Access Compliance Report

Public Rights-of-Way

(Curb Ramps)

Intersection ID: 18571	Main Street: BECKHAM_CT	Cross Street: RANDOLPH_RD	Location: NW
ADA ID: EB20C7C55172	Ramp Type: PerpDiag	Initial Pass/Fail: Fail	Overall Compliance: No
Codes/Mitigation Info/Possible Solution		Field Measurements/Component Compliance

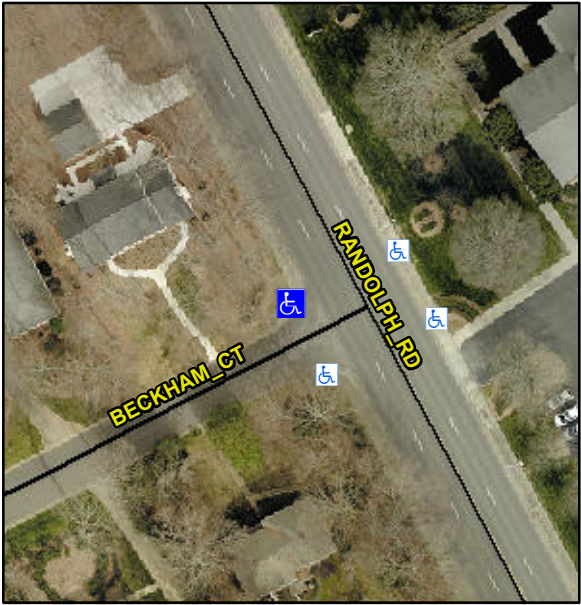
Possible Solutions:	Compliance	Description	Data	Compliance	Description	Data
	Remove & Replace Curb Ramp With Two New Directional Ramps or Equivalent.	N/A	Ramp Length (in)	71.0	No	Ramp Slope (%)	10.6
<p>Surveyor Notes:</p> <p>N/A</p> <p>PROW/ADA:</p> <p>Not Found, R304.5.1, R304.2.2</p>		No	Ramp Width (in)	46.0	Yes	Ramp XSlope (%)	0.5
		N/A	Flare Type LT	N/A	N/A	Flare Type RT	N/A
<p>Street 1 Name</p> <p>BECKHAM CT</p> <p>Stop Condition-Street 2</p> <p>StopSign</p> <p>Street 2 Name</p> <p>RANDOLPH RD</p> <p>Stop Condition-Street 1</p> <p>None</p>		N/A	Flare Slope LT (%)	N/A	N/A	Flare Slope RT (%)	N/A
		N/A	Flare Traversable LT?	N/A	N/A	Flare Traversable RT?	N/A
<p>Total Cost:</p> <p>\$ 3200.00</p>		N/A	Landing Length (in)	N/A	N/A	DWS Provided?	N/A
		N/A	Landing Width (in)	N/A	N/A	DWS Contrast?	N/A
		N/A	Landing Slope (%)	N/A	N/A	DWS Length (in)	N/A
		N/A	Landing X Slope (%)	N/A	N/A	DWS Full Width?	N/A
